Access Compliance Report

Public Rights-of-Way

Intersection ID: 21552	Main Street: COLONY_RD	Cross Street: GIVERNY_DR	Location: NE
ADA ID: 1BFDF14366B8	Ramp Type: PerpDiag	Initial Pass/Fail: Fail	Overall Compliance: No
		Severity Score: 25

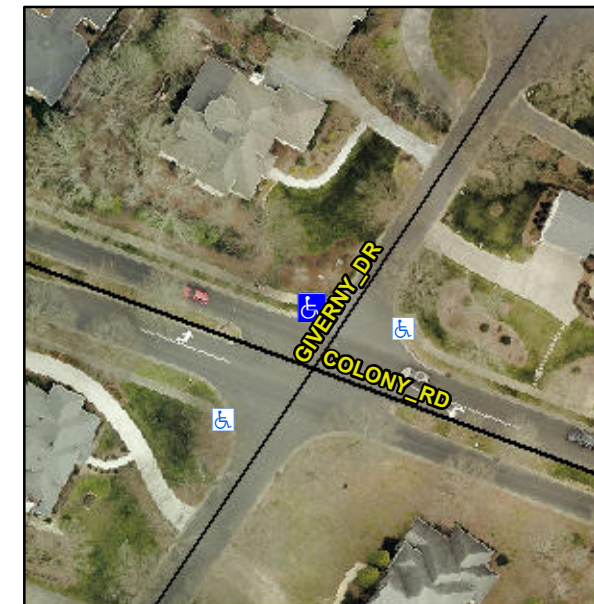
R304.5.3

Compliance	Description	Data	Compliance	Description	Data
N/A	Ramp Length (in)	80.0	Yes	Ramp Slope (%)	8.2
Yes	Ramp Width (in)	48.0	No	Ramp XSlope (%)	7.5
N/A	Flare Type LT	N/A	N/A	Flare Type RT	N/A
N/A	Flare Slope LT (%)	N/A	N/A	Flare Slope RT (%)	N/A
N/A	Flare Traversable LT?	N/A	N/A	Flare Traversable RT?	N/A
N/A	Landing Length (in)	N/A	N/A	DWS Provided?	N/A
N/A	Landing Width (in)	N/A	N/A	DWS Contrast?	N/A
N/A	Landing Slope (%)	N/A	N/A	DWS Length (in)	N/A
N/A	Landing X Slope (%)	N/A	N/A	DWS Full Width?	N/A
N/A	Landing Curb? (Y/N)	N/A	N/A	DWS Offset (in)	N/A
N/A	Shared Landing?	N/A			
N/A	Gutter Ponding?	N/A	N/A	Gutter Slope (%)	N/A
N/A	Gutter Lip Ht (in)	N/A	N/A	Gutter X Slope (%)	N/A
N/A	Painted X Walk1?	No	N/A	Painted X Walk2?	No
	X Walk 1 Direction	To SW		X Walk 2 Direction	To SE
N/A	X Walk 1 Width (in)	N/A	N/A	X Walk 2 Width (in)	N/A
	X Walk 1 Slope (%)	1.1		X Walk 2 Slope (%)	7.0
	X Walk 1 X Slope (%)	8.9		X Walk 2 X Slope (%)	0.3

Remove & Replace Curb Ramp With Two New Directional Ramps or Equivalent.
